Field Service Bulletin

Behind the Cab System Mount Modification

ENP-599
October 6, 2017

Figure 2. Above: The existing mounting bracket and isolator system is removed and replaced with a modified bracket and four-point isolator system (below).

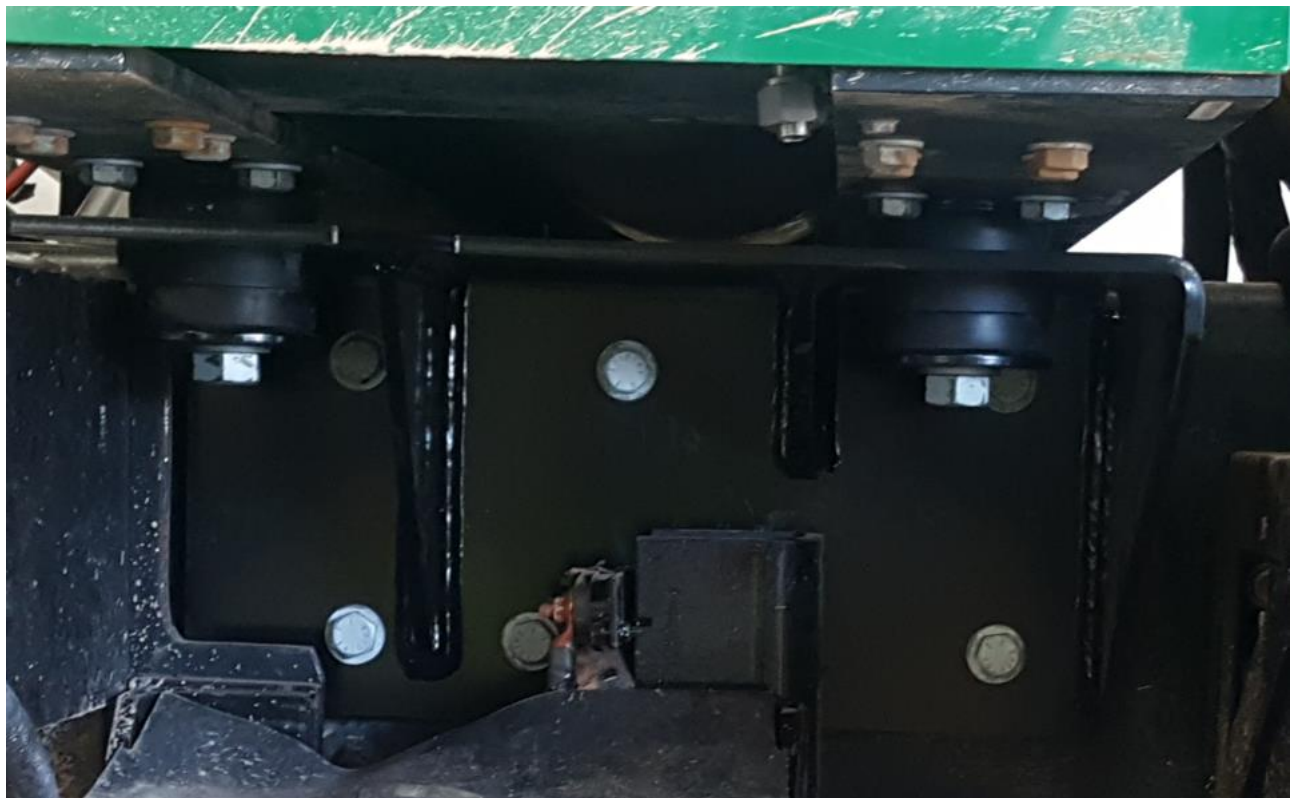
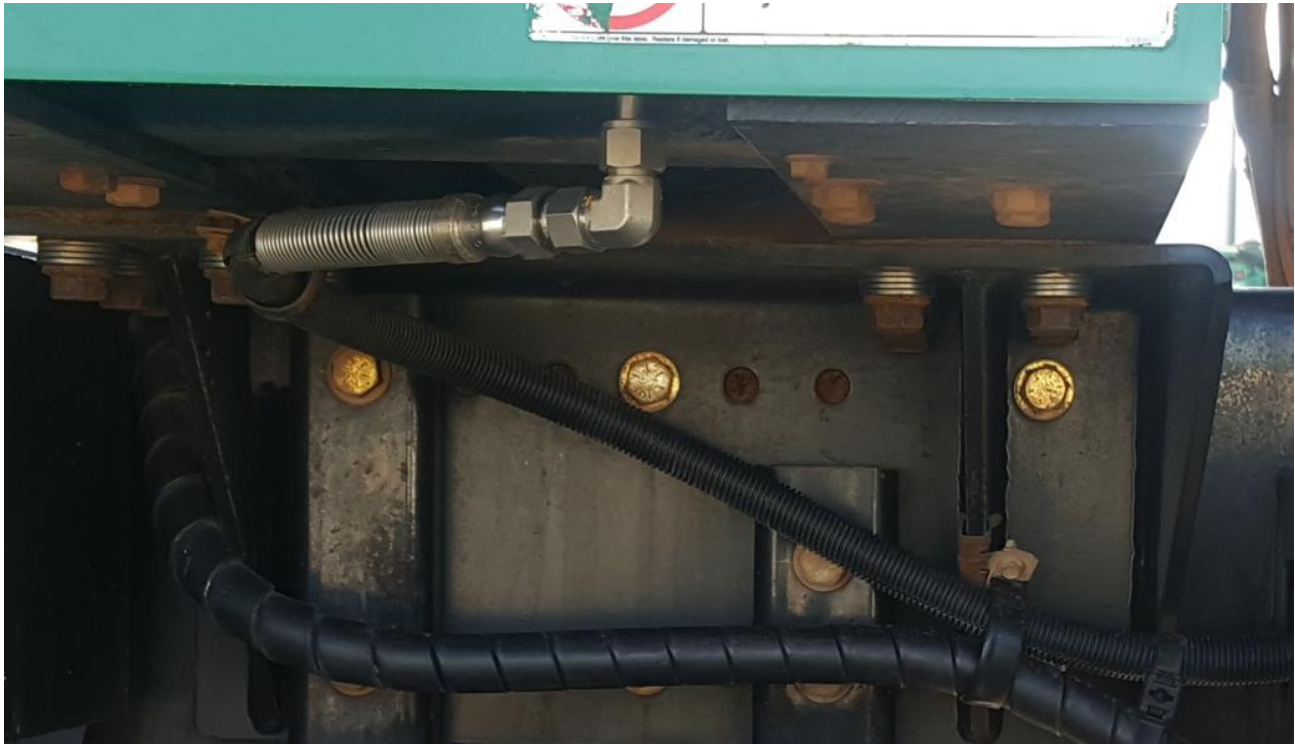
Bolts on 22523000 behind the cab (BTC) system mounts on one customer's fleet are breaking due to excessive vehicle frame twist. This is a modification of an existing design to help mitigate this issue.

The existing mounting bracket, system isolators and bolts are replaced with a modified bracket and isolator system.

*Figure 6. Overhead view showing beams and drilling locations when work is completed.
Note the two locations and the additional washers needed.*

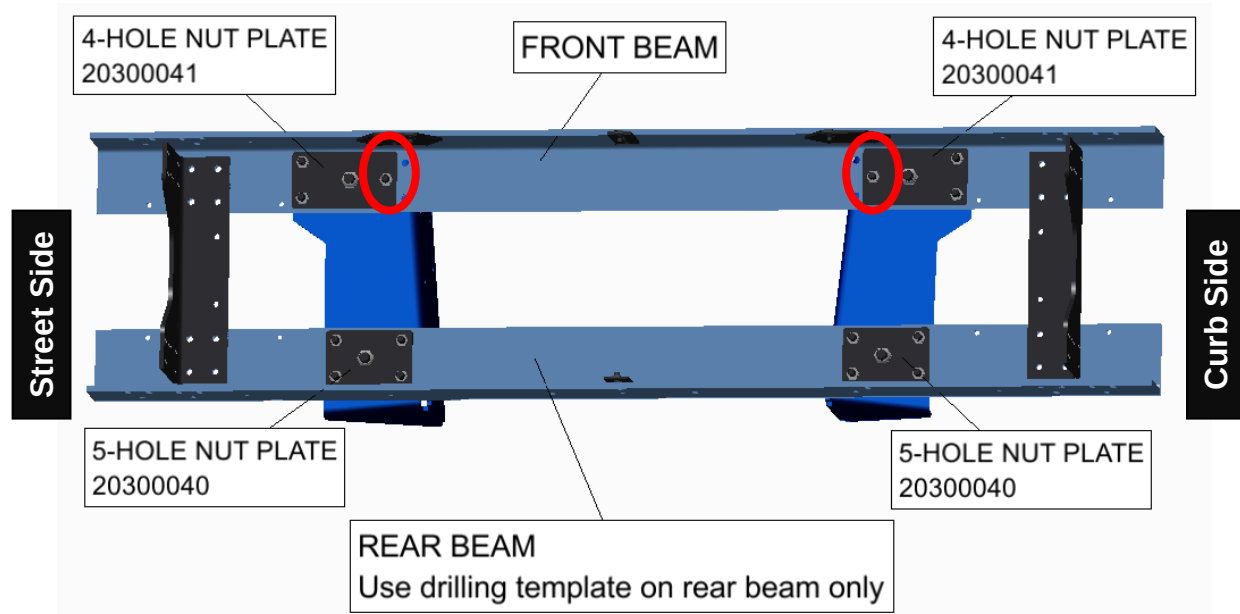
NOTE: Two bolts on the front beam require **both** an SAE washer and a USS washer underneath the bolt head. The two holes are countersunk and will “dish” into the hole instead of properly spreading the clamp load of the joint. See Figures 6 and 12.

Figure 7. Fuel system beams before drilling. The drilling templates are positioned on the REAR beam only.

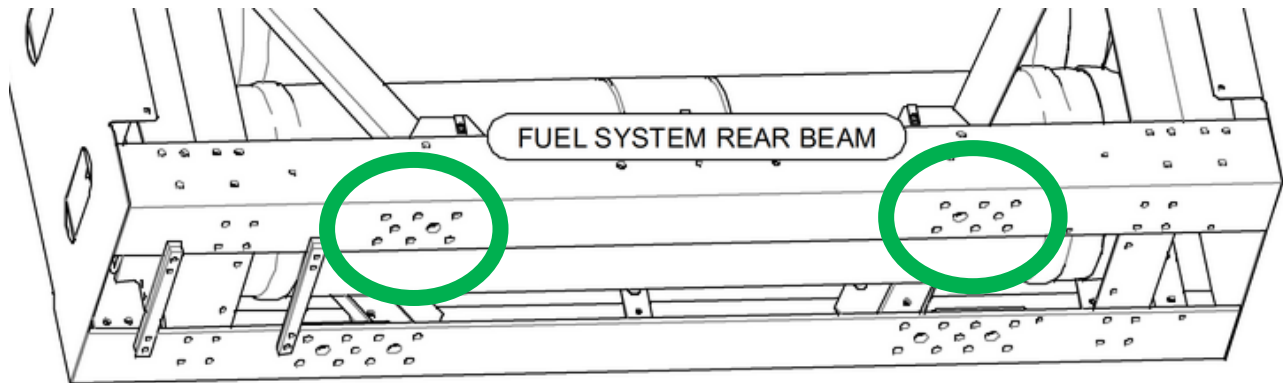
8. Remove the existing nut plates and rubber isolators.
9. Examine the vehicle chassis and fuel system frame for wear or corrosion, and clean all surfaces.
10. The fuel system frame can remain in place, but new holes are needed in the lower mounting brackets, see Figures 5, 6 and 7.
 - a. A drilling jig is provided (part number 22500242) – this is for the **REAR** beam only.
 - b. The drilling guide is NOT used for the front beam.
11. Match and mount the drill template to two existing holes on the REAR bracket.
12. Bolt the template in place as shown in Figure 8 and drill a 3/16-in. pilot hole through the center hole in the template and the lower angle.
13. Remove the template and enlarge the holes to 15/16-inch.

Figure 13. The REAR isolator mounting parts must be arranged as shown.

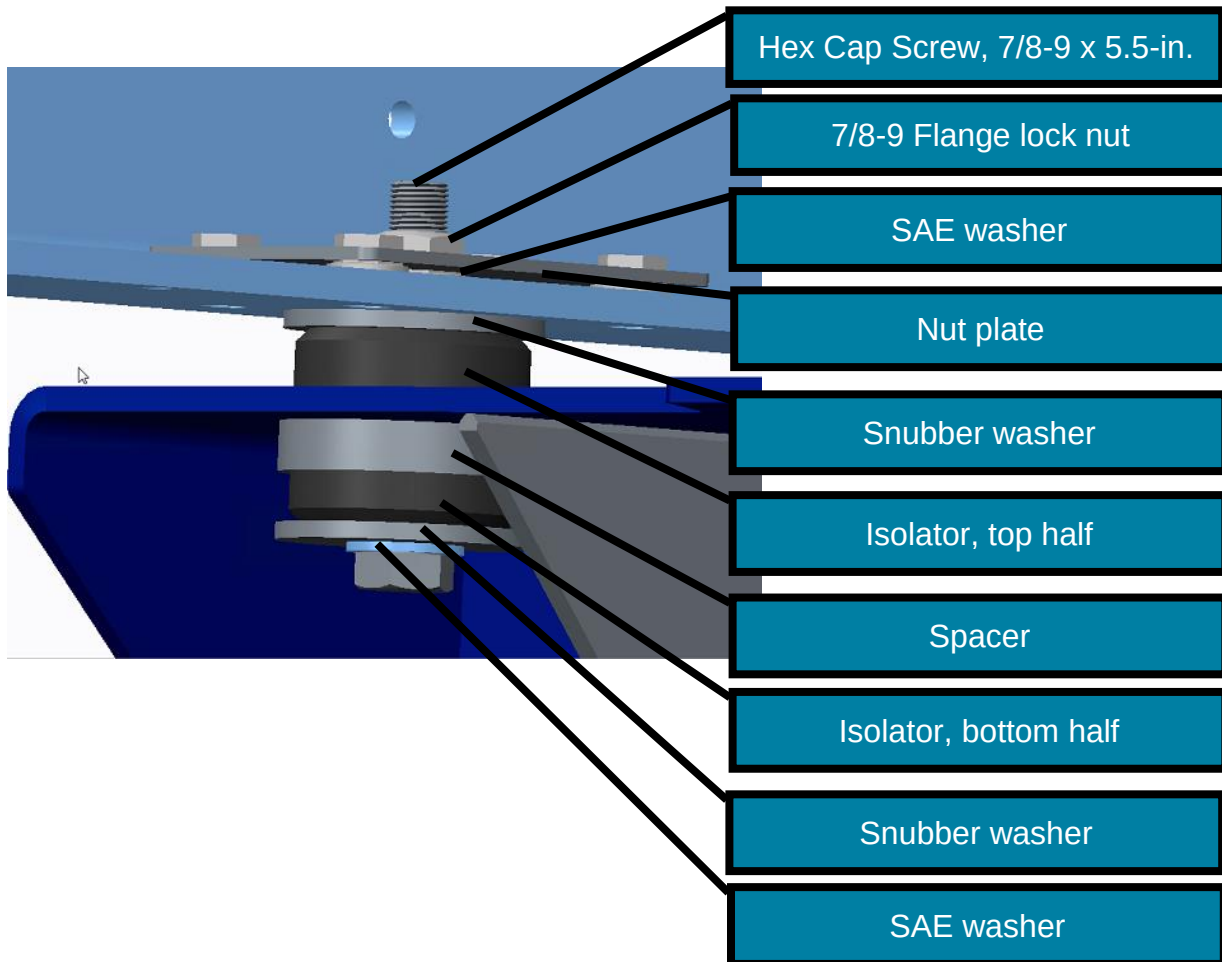
15. Bolt the new system mounting brackets, washers, spacers and isolators in place on the fuel system cabinet.
 - a. The isolator stack component sequence is critical, see Figures 13, 14 and 15.
